# SERVICE BULLETIN

**Service Bulletin No. / Date:** SB TMG 300-0001 P1, Revision 1 / May 4, 2022

**Subject:** Time Between Replacement (TBR) and Time Between Overhaul (TBO)

**Type affected:** Centurion 3.0 (CD-300)

Fig. 1 Engine Version Identification

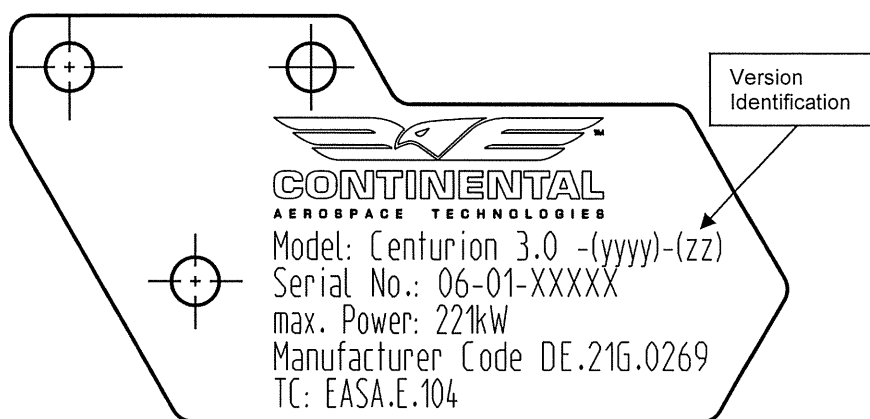
**Time of Compliance:** **Centurion 3.0 (CD-300) – Version 01 (see remarks for engine version identification):**  
1,200 flight hours or 12 years after the date of initial operation, whichever occurs first. The date of initial operation is the date on which the engine is operated for the first time or the 180<sup>th</sup> day after delivery of Continental Aerospace Technologies GmbH, whichever occurs first.

**Centurion 3.0 (CD-300) – Version 02 (see remarks for engine version identification):**  
2,000 flight hours or 12 years after the date of initial operation, whichever occurs first. The date of initial operation is the date on which the engine is operated for the first time or the 180<sup>th</sup> day after delivery of Continental Aerospace Technologies GmbH, whichever occurs first.

Identification of Engine Version on Type Plate:
